Re: Great Southern Broadcasting Company, Inc.
WAMB(AM), Nashville, TN
Facility ID No.: 72879
File No. BP-20070618ABU

This letter refers to the above-captioned application for a minor modification of AM broadcast station WAMB to add nighttime operation.

Title: MAP
Engineer:
Projection: Lambert
Projection Coordinates: 33 51 22 N 88 22 47 W
Date: Mon Oct 29 14:20:57 2007
Scale Factor: 87.04 km/cm
— PC Str: WOAI
- - - IX Str: WAMB

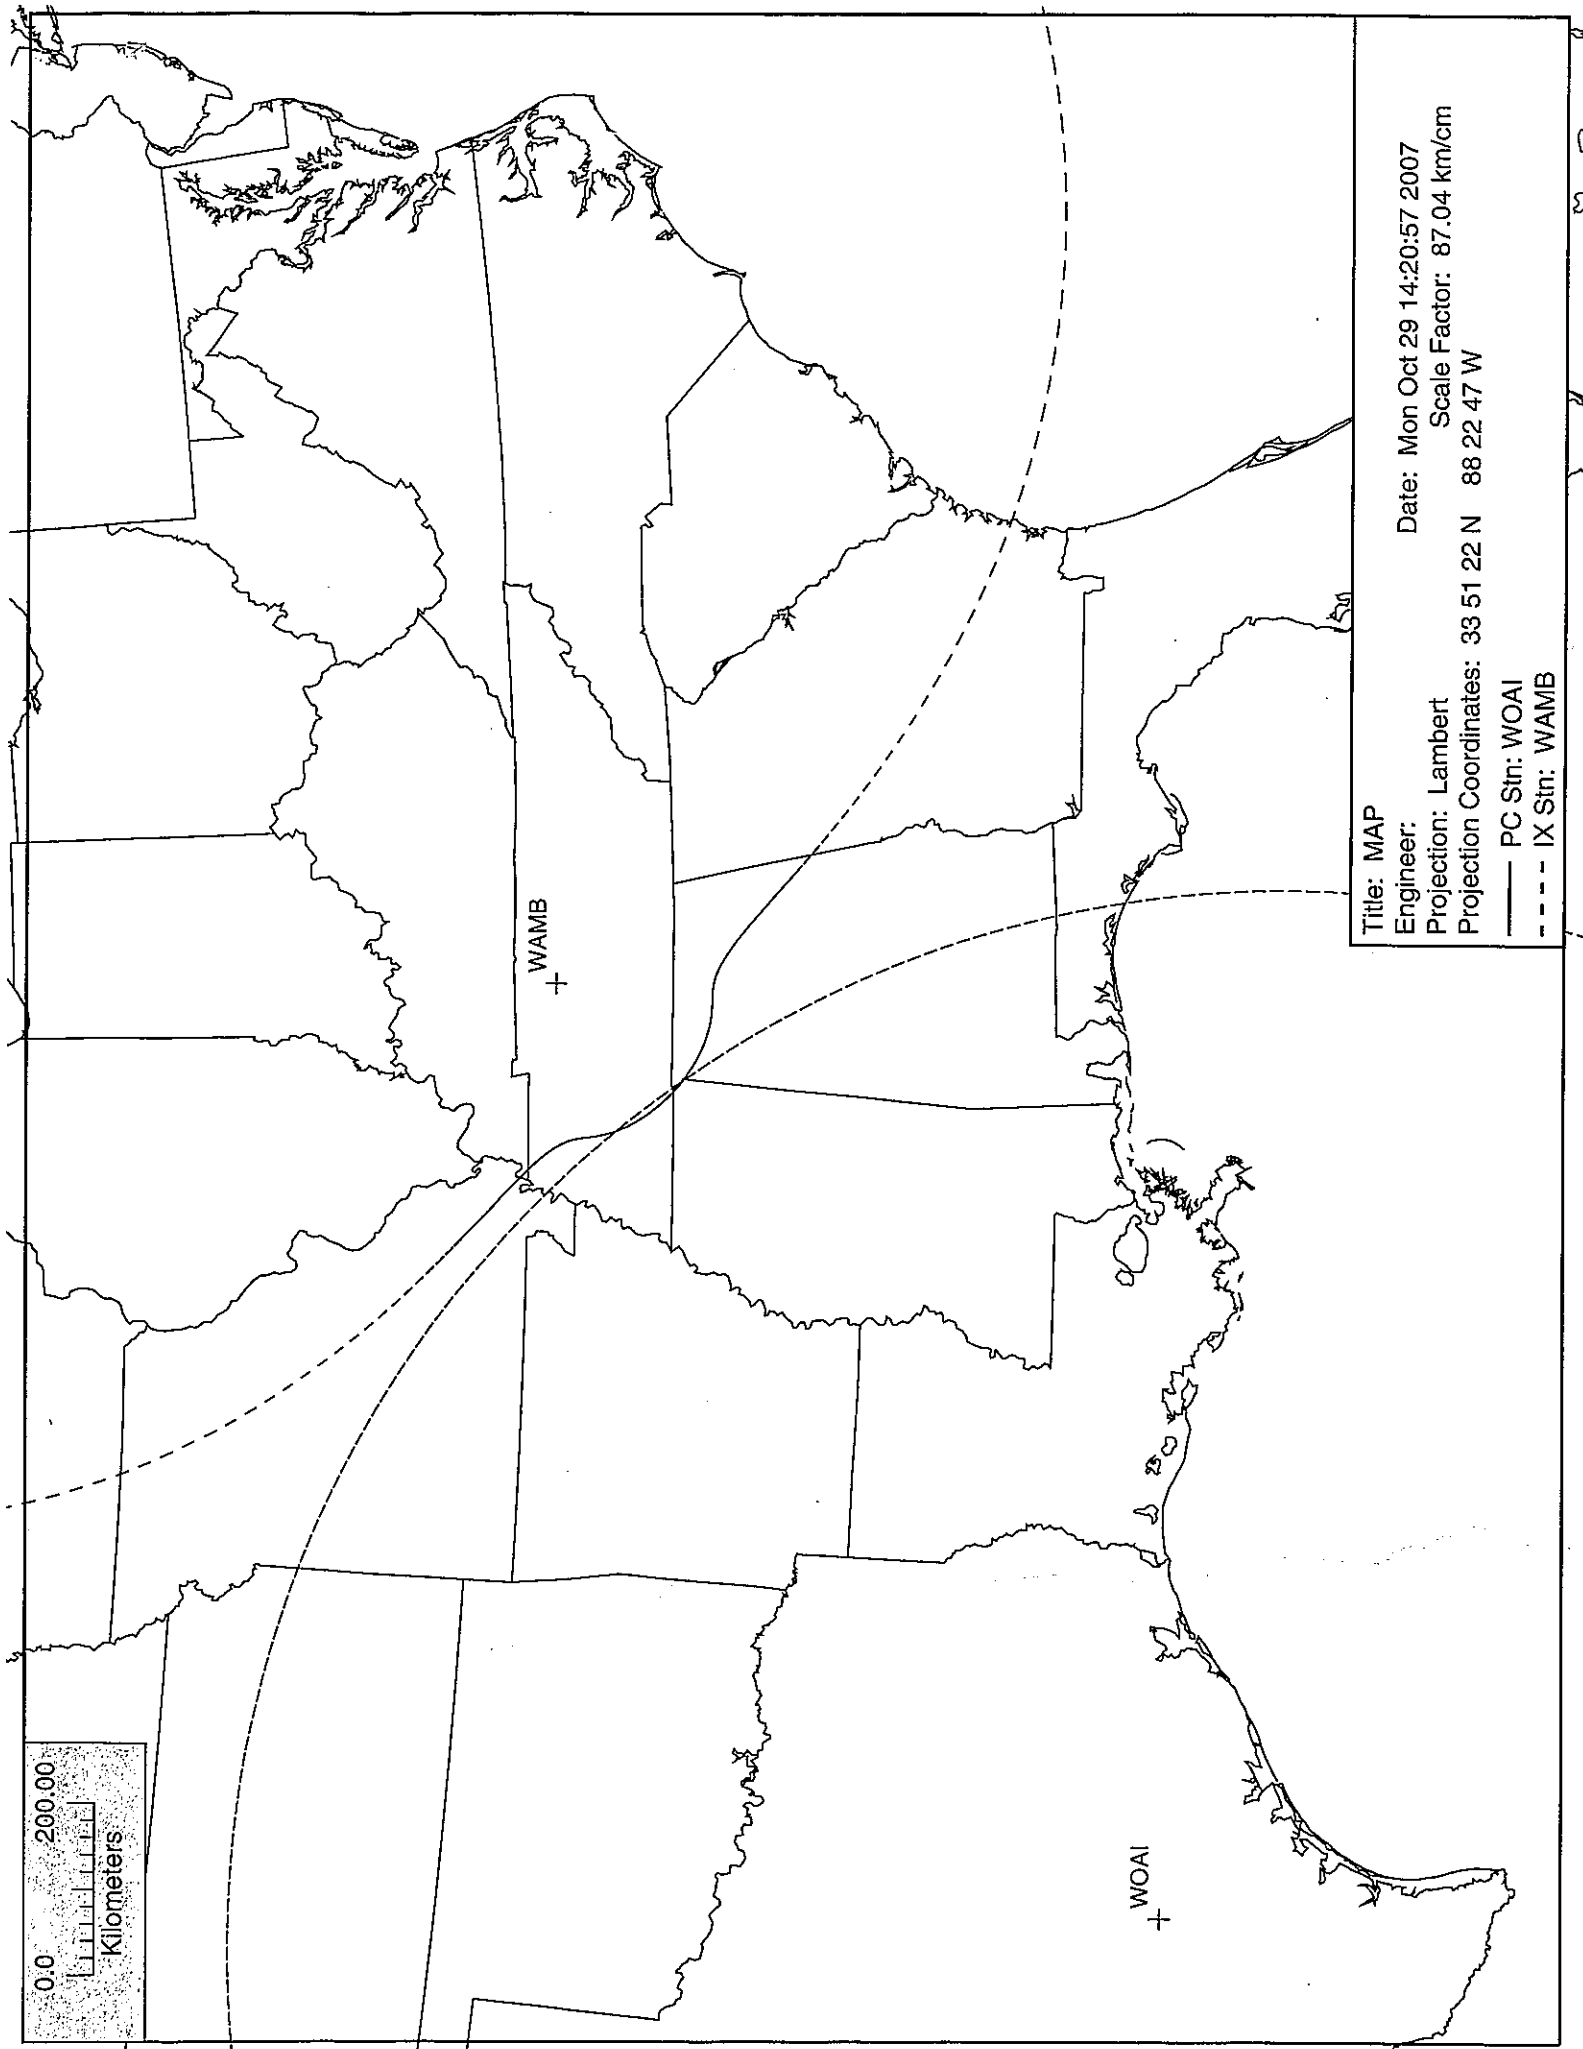
An engineering review of the application, as amended, reveals that the proposed nighttime 0.025 mV/m-10% skywave contour will overlap the 0.5 mV/m-50% skywave contour of co-channel Class A station WOAI, San Antonio, Texas, consequently, the application is unacceptable for filing in violation of 47 CFR Section 73.182.¹ (See attached exhibit)

Accordingly, the application IS HEREBY DISMISSED. This action is taken pursuant to 47 CFR Section 0.283.
